**CITY OF SUNNYVALE
REPORT
Planning Commission**

September 27, 2004

SUBJECT: **2004-0603 - Classic Communities** [Applicant] **Sato America Inc** [Owner]: Application for related proposals on a 7-acre site located at **543, 545 and 549 East Weddell Drive** in an M-S/ITR/R-3/PD (Industrial & Service/Industrial to Residential/Medium Density Residential/Planned Development) Zoning District. (APN's: 110-14-178 through 181; 110-14-164 and 165);

Motion **Special Development Permit** to allow demolition of two buildings and construction of 130 new town homes, and;

Excerpt from Fair Oaks/Tasman Plan Figure 3

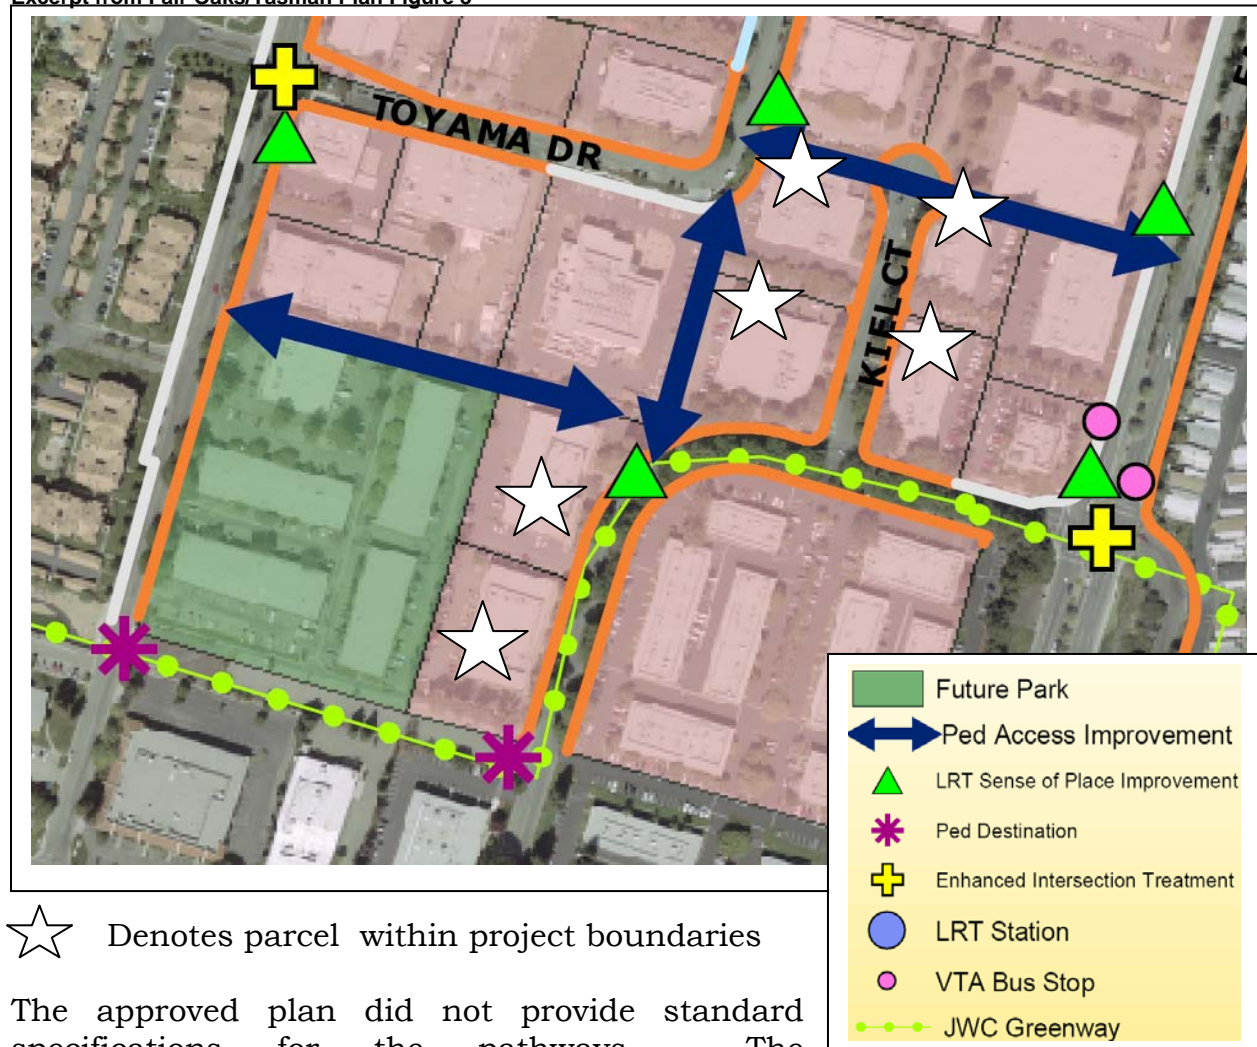
Neighborhood pedestrian and bicycle circulation is also required through the subject site by the recently adopted Fair Oaks/Tasman Pedestrian and Bicycle Circulation Plan. The three identified pathways of the plan involve the subject site. Staff is recommending conditions of approval requiring dedication and improvement of two of the three pathways.

The approved plan did not provide standard specifications for the pathways. The Transportation Division has consulted other resources and determined that 12-14 feet is the ideal amount of space for the paths to accommodate an eight-foot surface and shoulder landscaping and lighting. Minimum requirements would be for a five-foot wide surface within 8-10 feet space to create a comfortable experience. Within Sunnyvale single-family residential neighborhoods several comparable pedestrian paths of 10 feet wide exist along rear and sideyards of

Staff recommends the developer be required to dedicate a minimum of 12 feet for the east west path from the future park, 12 feet for the short Weddell drive bend connection, and 12 feet for the Karlstad to Kiel section, and defer the remainder of Kiel connector to neighboring property and defer the north south connector to the neighboring property. Staff's recommendation accounts for approximately 48% path requirements needed to implement these improvements within the subject project. The recommendation provides two complete segments without half improvement require future development to complete and allowing appropriate deferment of other paths to neighboring properties.

The applicant has proposed only the seven-foot half improvement for the east west Karstad connector and the full short connector at the bend of Weddell Drive. The east west park connector is not proposed by the applicant. Staff's condition to accommodate the 12-foot path will likely require the applicant to reconfigure the sub-area to provide appropriate separation from the units and the path. The 12-foot north dedication will require adjustments to one building and some parking as well.

The applicant has also proposed that 6-foot chain link fences be installed around the paths. This is unacceptable to staff and does not meet the intent of the plan for providing open integrated comfortable pedestrian and bicycle circulation. Staff has included a recommended condition that the abutting fence be of a decorative design of 3 feet not to exceed 4 feet in height with gates for connections to individual walkways within the site. The fence is to be located on the private property. Staff has also accounted for the proposed dedicated area as part of the projects total landscaping and usable spaces figures and does not recommend requiring side or rear yard setbacks from the newly dedicated property line.

8. Submit a revised site plan for approval by the Director of Community Development that includes a 12-foot wide dedication for pedestrian paths along the north project boundary from Karlstad Drive to Kiel Court, from the west boundary of the future park to Weddell Drive, and for the connection at the Weddell Drive bend.

19. Prior to issuance of a building permit, improvement plans for the Pedestrian Path dedicated areas are to be submitted for approval by Director of Community Development. The plans are to include an eight-foot wide path, landscaped shoulders, entryway bollards, pedestrian lighting, and other standard features for pedestrian paths within the dedicated area and decorative three-foot fences with gates on adjacent private property.
20. At the expense of the developer the pedestrian paths improvements are to be installed prior to occupancy of the residential units.
